CHANGE REQUEST

⌘ **33.102 CR XXX** ⌘ rev ⌘ Current version: **6.0.0** ⌘

Title:	⌘ Clarification on Authentication re-attempt parameter		
Source:	⌘ NEC		
Work item code:	⌘ TEI6	Date:	⌘ 19/April/2004
Category:	⌘ F	Release:	⌘ Rel-6
	Use <u>one</u> of the following categories:		Use <u>one</u> of the following releases:
	F (correction)	2 (GSM Phase 2)	
	A (corresponds to a correction in an earlier release)	R96 (Release 1996)	
	B (addition of feature),	R97 (Release 1997)	
	C (functional modification of feature)	R98 (Release 1998)	
	D (editorial modification)	R99 (Release 1999)	
	Detailed explanations of the above categories can be found in 3GPP TR 21.900 .	Rel-4 (Release 4)	
		Rel-5 (Release 5)	
		Rel-6 (Release 6)

Figure 13: Reporting authentication failure from VLR/SGSN to HLR

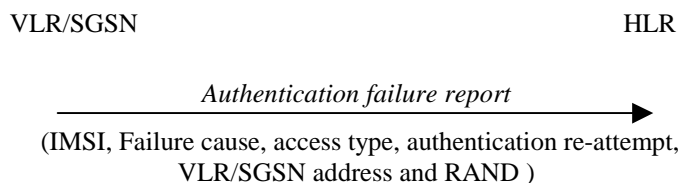
Reason for change:	⌘ The authentication re-attempt parameter was introduced in REL4 to be used by a Fraud Detection System (FDS) in the Home Network to help identify and manage potential fraud scenarios. However, it was pointed out by the CN4 LS (S3-030672) that the detailed usage of this parameter is unclear. Besides, CN4 requested SA3 in the later LS (N4-040247) to provide more information in the 33.102 about the criteria when the authentication re-attempt parameter is set in VLR and SGSN. Therefore, this CR proposes to provide all criteria the authentication re-attempt parameter is set in VLR and SGSN.
Summary of change:	⌘ This CR proposes to add new sub clause to describe the all criteria the authentication re-attempt parameter is set in VLR and SGSN. Together with above updates, the reference section is updated accordingly.
Consequences if not approved:	⌘ Due to unclear definition of the authentication re-attempt parameter, VLR and SGSN may not be designed properly and this may lead the FDS function ineffective.

2. Failure cause code. The possible failure causes are either that the network signature was wrong or that the user response was wrong;
3. Access type. This indicates the type of access that initiated the authentication procedure;
4. Authentication re-attempt. This indicates whether the failure was produced in a normal authentication attempt or it was due to an authentication re-attempt (there was a previous unsuccessful authentication). [Details are provided in subclause 6.3.6.1](#);
5. VLR/SGSN address;
6. RAND. This number uniquely identifies the specific AV that failed authentication.

6.3.6.1 Authentication re-attempt

The serving network sets the Authentication re-attempt to “true” if the second authentication described in the following cases results in an authentication failure report.

- Authentication with (P-)TMSI failed in MS (reject cause 'MAC failure') and new authentication procedure (re-attempt) is taken because an IMSI obtained by the followed IDENTITY REQUEST procedure does not match to the original IMSI that linked with (P-)TMSI. Details are provided in TS 24.008 [23]

- Authentication failed in MS (reject cause 'GSM authentication unacceptable') and new authentication procedure (re-attempt) is taken after MSC obtains UMTS authentication vectors from HLR. Details are provided in TS 24.008 [23]

- Authentication failed in MS (reject cause 'synch failure') and new authentication procedure (re-attempt) is taken after MSC obtains new authentication vectors from HLR for re-synchronisation. Details are provided in TS 24.008 [23]

- SRES mismatches with (P-)TMSI in VLR/SGSN and new authentication procedure (re-attempt) is taken because an IMSI obtained by the followed IDENTITY REQUEST procedure does not match to the original IMSI that linked with (P-)TMSI. Details are provided in TS 23.012 [24] and TS 23.018 [25]

Otherwise Authentication re-attempt is set to “False”
